ChiCycle Oppose the Inappropriate Conversion of Westgate Pavements into Shared Use Cycle Tracks

The consultation period for [Traffic Regulation Order \(TRO\) CHS9038RC](#) closes on the 5th August 2021.

ChiCycle advise that this TRO contains some welcome changes (New Zebra Crossings) that should be encouraged; Other elements in this order might become worthwhile infrastructure with improved design (e.g. a Dutch Style Roundabout); However, we believe the creation of sub standard shared cycle tracks around the Sherborne-Rd/Westgate junction (TRO items iii & iv) should be strongly opposed for the following reasons:

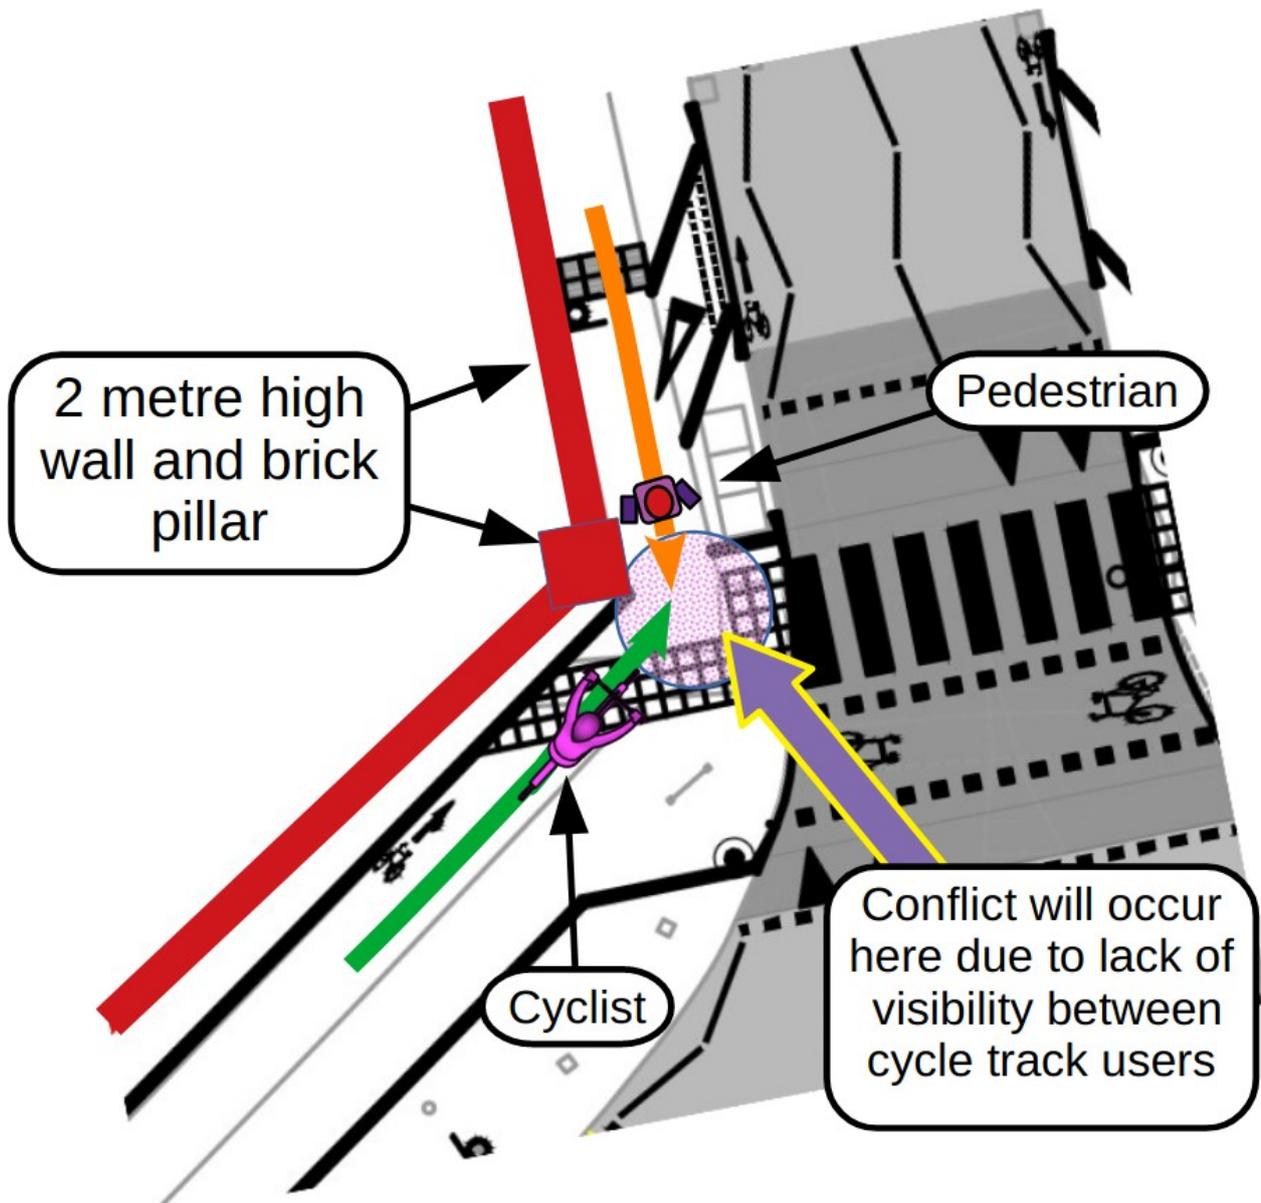
- 1). Cyclists will round corners with virtually zero forward visibility directly into the path of oncoming pedestrians.
- 2). The proposed width of sections of shared cycle tracks are well below minimum widths recommended by DfT. Indeed, shared use cycle tracks are inappropriate in this location according to current guidelines.

The image above shows an annotated clip taken from the currently proposed scheme. The route of cyclists around blind corners will clearly inconvenience/endanger pedestrians. Frail elderly members of the community are particularly vulnerable to injury from collisions with bicycles on these blind corners.

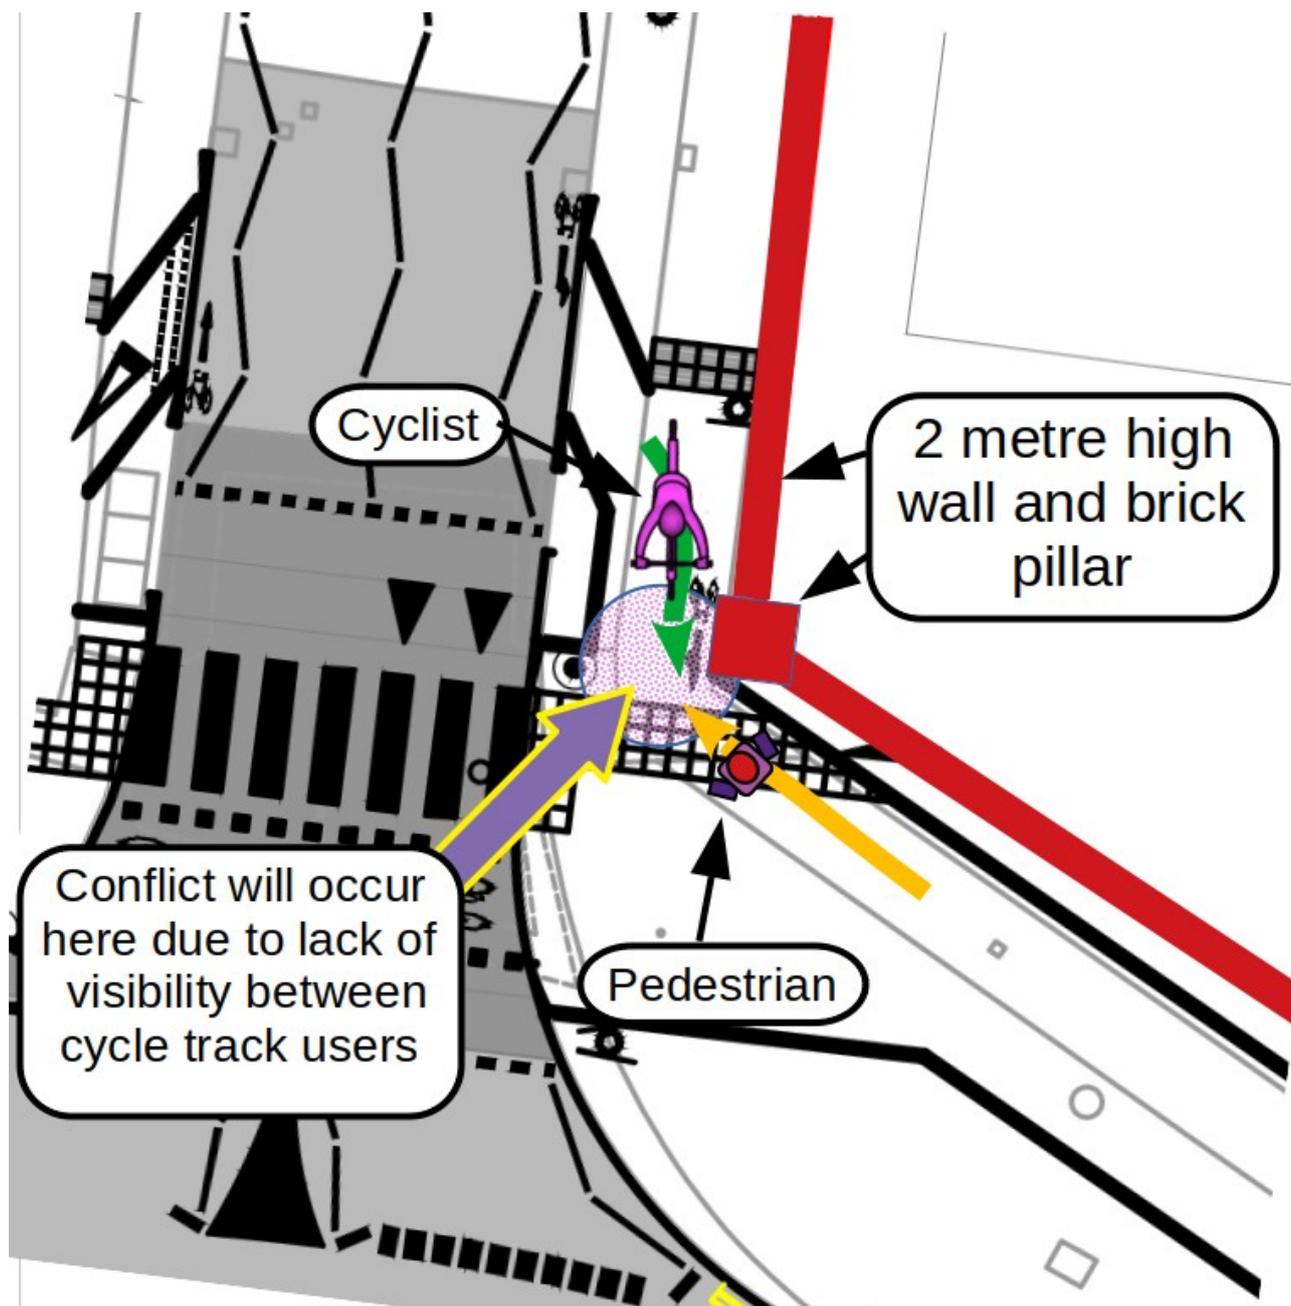
3) Conflict between cyclists and pedestrians will be inevitable on the North West pavement of this roundabout.

5.9.3 “Objects such as walls, fences and trees should not be sited close to the cycle track on the inside of bends as this will potentially affect the visibility”

This guidance applies to all new cycle infrastructure (as in this case) but is clearly not adhered to in these proposals. In this example, the apex of the corner is bounded by the edge of a substantial brick pillar and wall, giving no visibility between approaching pedestrians and cyclists.

The minimum inside radius given in LTN1/20 Table 5-7 is **four metres** but at the brick pillars this scheme uses a radius of **zero metres!**

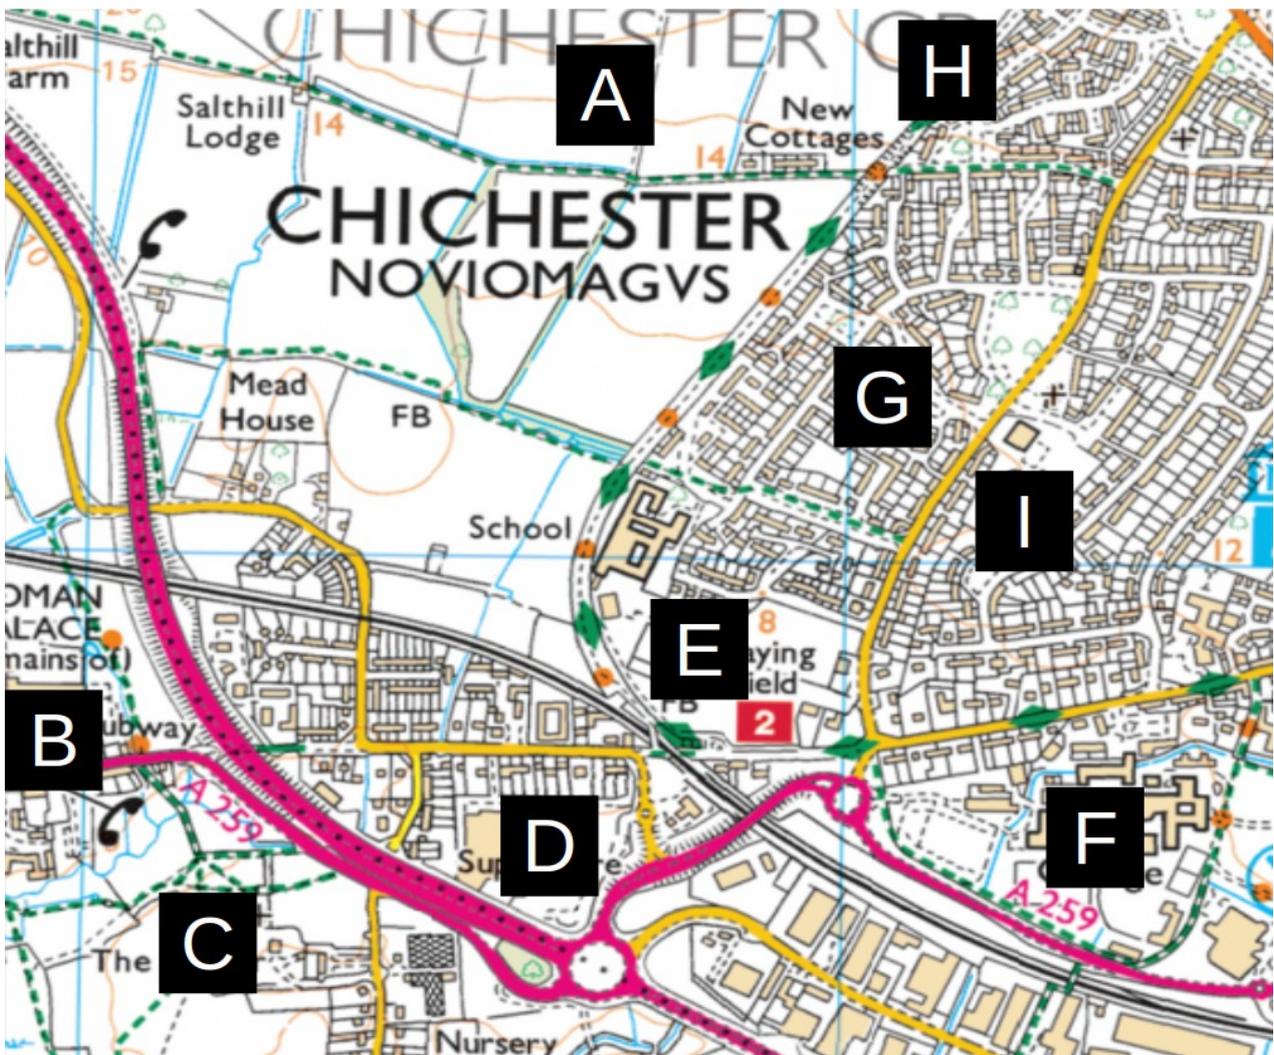
7) Conflict between cyclists and pedestrians is also inevitable at this blind corner at the North East pavement of the roundabout.

The image above shows the approaching view turning north into Sherborne Road of a parent taking children to Parklands Infant and Nursery School or returning from First Steps Childcare at Chichester College.

Can it be justified for families to share space at this sharp corner with busy commuter cycle traffic approaching? Will mobility impaired and partially sighted residents feel safe using the proposed infrastructure that will have cyclists rounding this sharp corner without the protection of compliance with DfT forward visibility criteria for shared use cycle tracks?

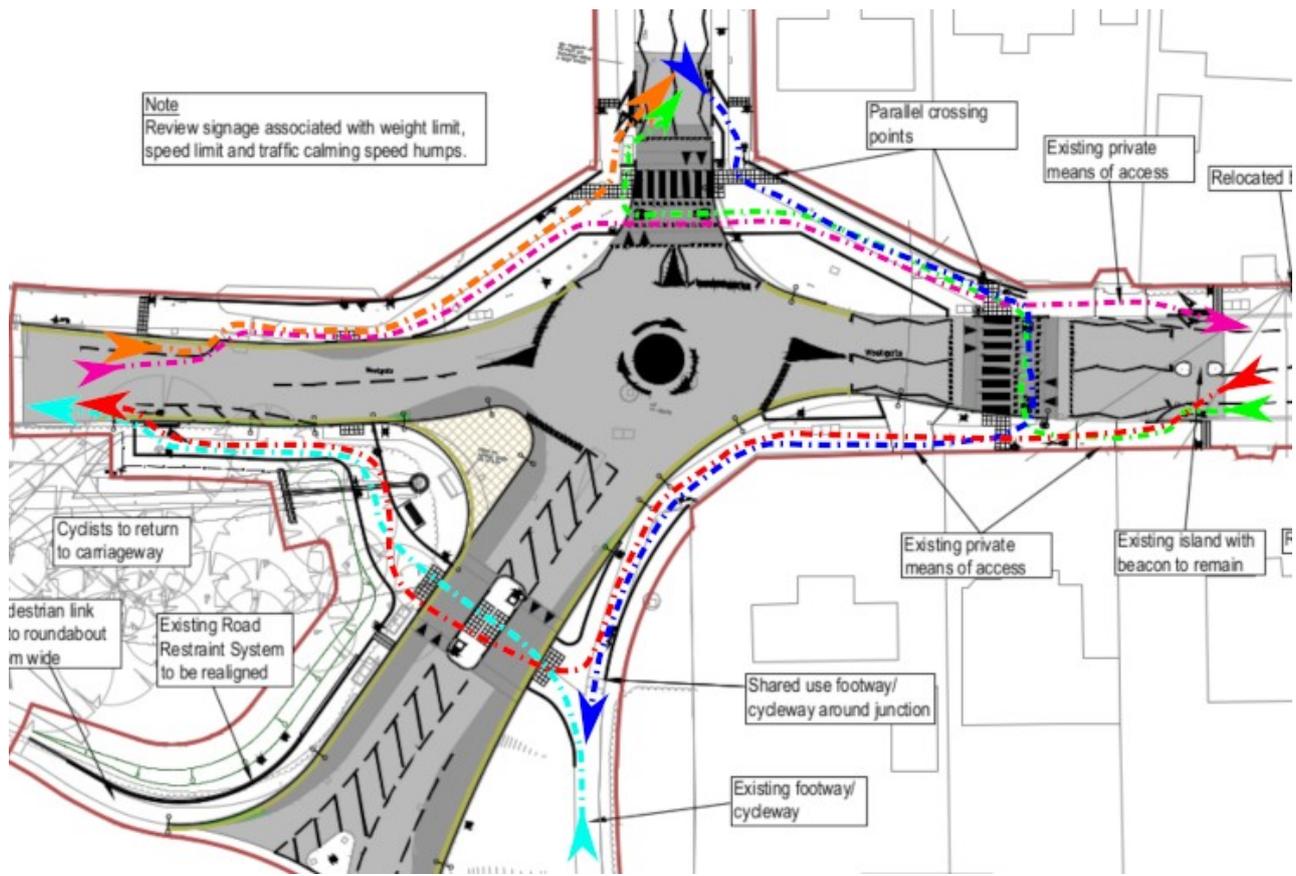
The coloured lines in the diagram (shown below) represent paths and desire lines that cyclists are likely to follow after the proposed conversion of the footways into shared use cycle-tracks.

This design will result in conflict that will particularly disadvantage vulnerable pedestrians. Parents pushing prams or holding a child's hand, elderly or disabled pedestrians will be unable to avoid walking on narrow shared use cycle-tracks if they need to negotiate this junction.

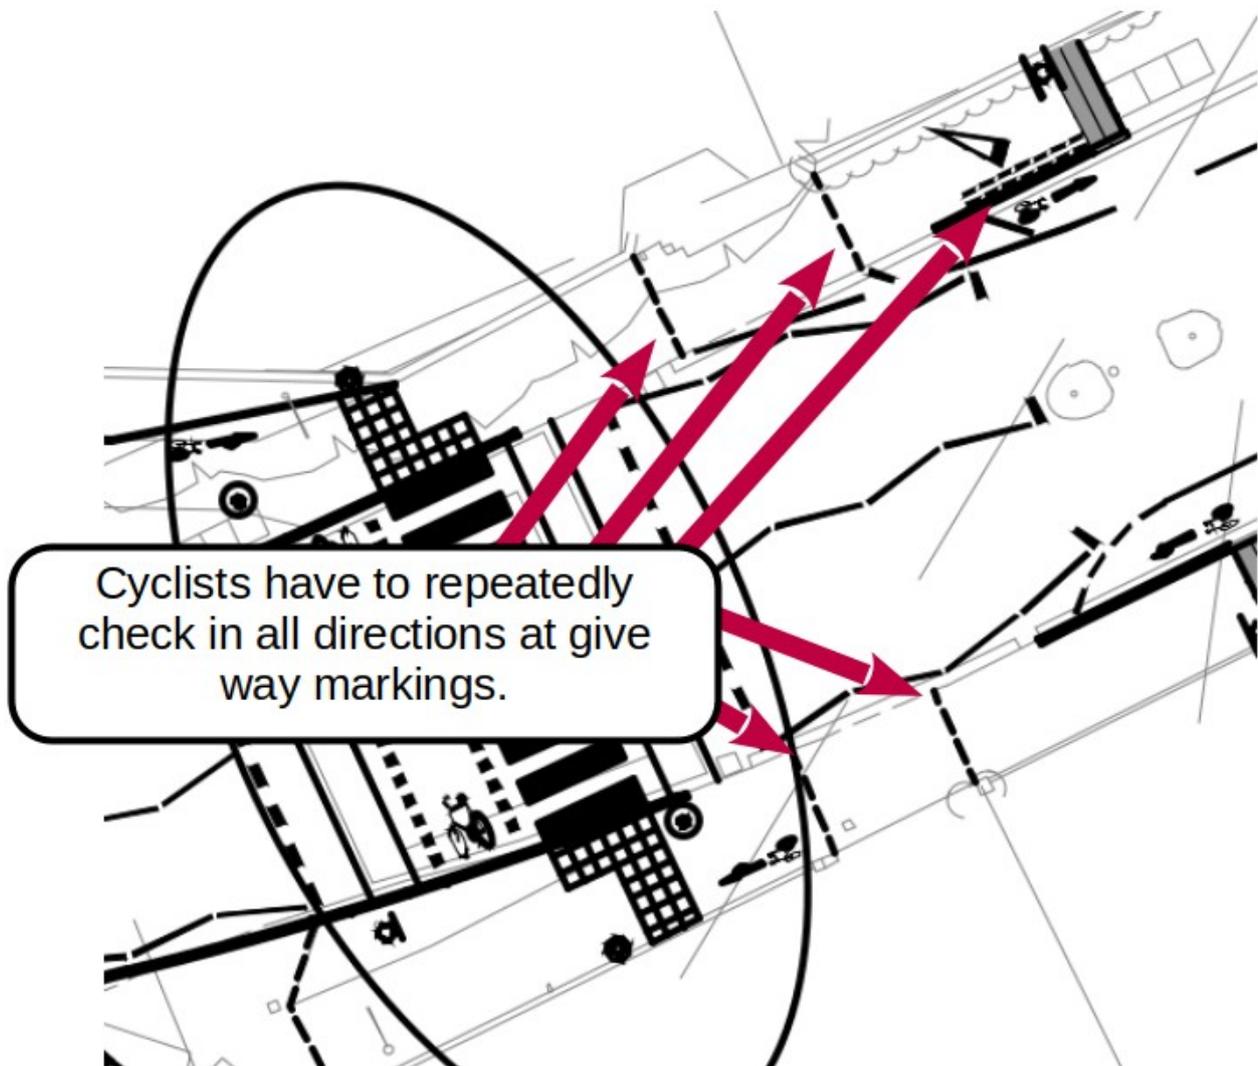
Both parallel crossings at the junction between Sherborne-Rd/Westgate will carry two way cycle traffic and therefore need to be a minimum width of 3 metres to comply with DfT minimum standards for crossings. The widths of the cycle crossings shown in the proposed plans are only 1.5 metres in width. This is only 50% of the DfT minimum width prescribed for use with two way parallel cycle crossings.

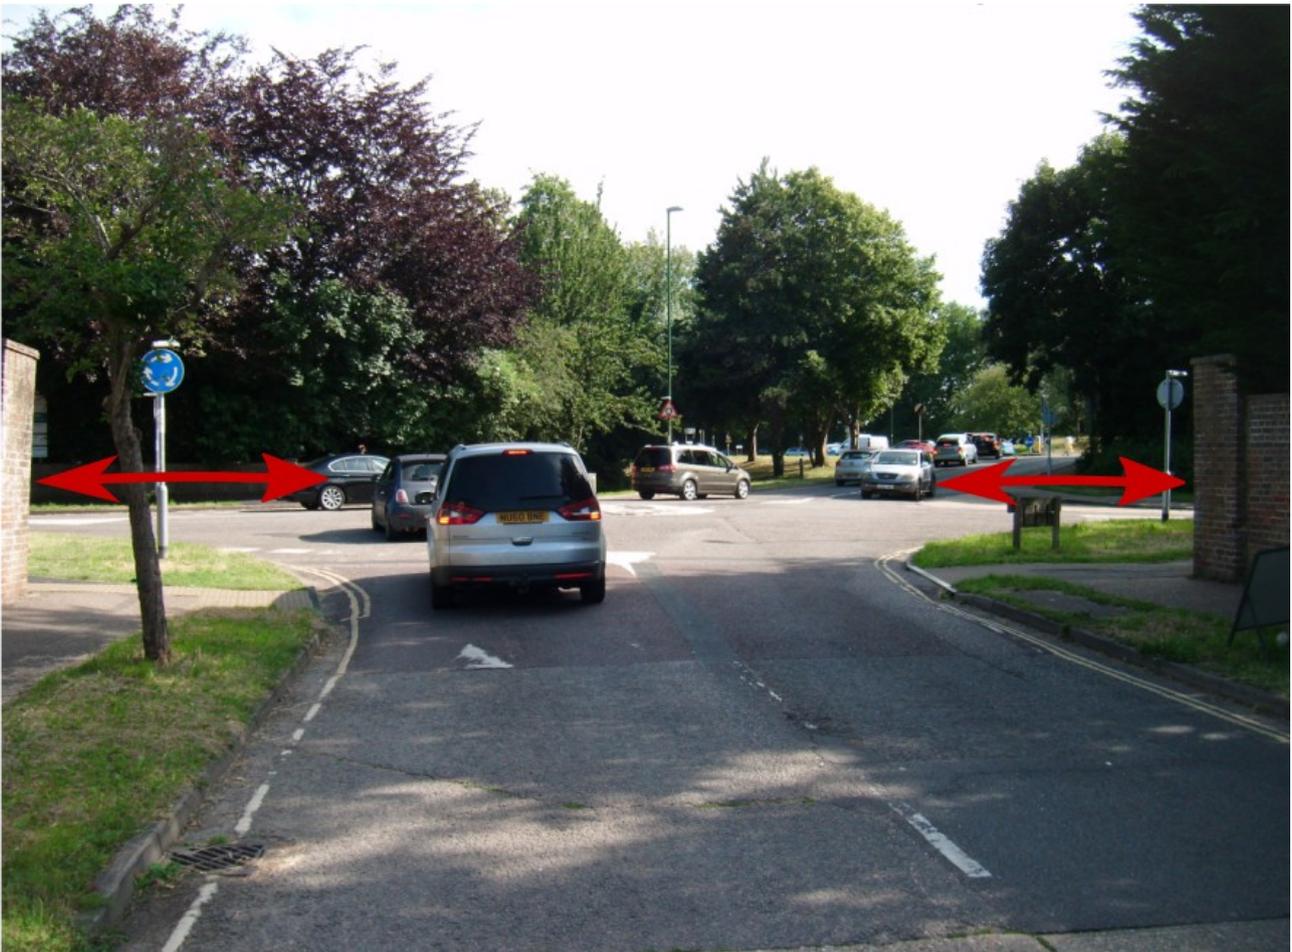
The driveways shown have virtually no splay visibility to see approaching cycles! If these proposals go ahead, it will be necessary for cyclists to come to a virtual standstill at each driveway exit where they must check in all directions for both vehicles entering these access-ways and also for vehicles pulling out onto the highway. The huge effort involved in making these extremely difficult observations while balancing on a narrow pavement at slow speeds, will entirely negate any benefit from attempting to cycle on this sub standard shared use cycle provision.

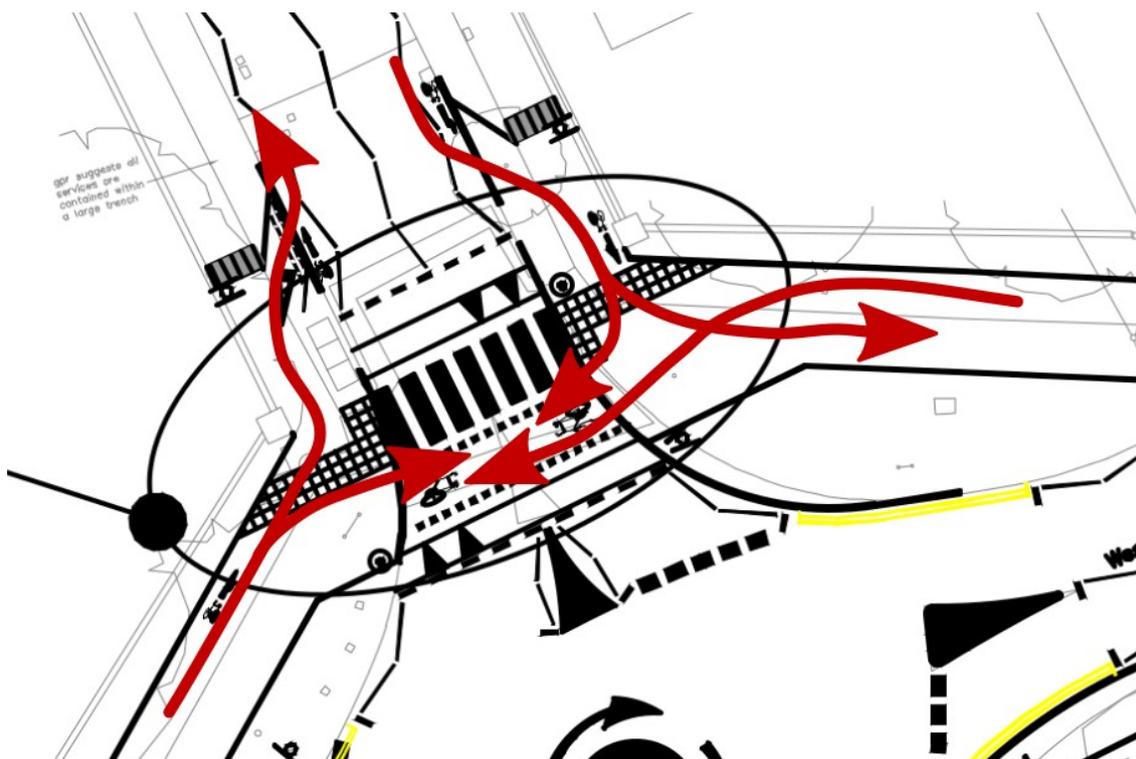
This TRO proposes to route cycle traffic over a parallel crossing on Sherborne Rd where visibility of approaching cyclists is obscured by two metre high brick walls and pillars. Cyclists making realistic forwards progress along the cycle track to this crossing, will emerge suddenly into the view of drivers leaving them with little time to react. Less experienced cyclists may be less aware of the limited visibility safety hazard presented by this proposed crossing. Students from Bishop Luffa School may attempt to make reasonable progress along this section of proposed cycle track.

There is only a 3 metre distance between the brick pillars obscuring visibility of approaching cyclists and from the kerb line of Sherborne Rd.

A cyclist travelling at speed of 14MPH will cover a 3 metre distance in a timespan shorter than half a second.

The limited visibility issue where cyclists will suddenly appear onto the proposed crossing after suddenly emerging from behind a tall brick wall and pillar, is illustrated in the following photograph.

The stopping distances given in the Highway Code indicate that drivers have an average reaction time in excess of half a second. Visibility of approaching cyclists will not be adequate for motorists to give way at the proposed Sherborne Rd parallel crossing.
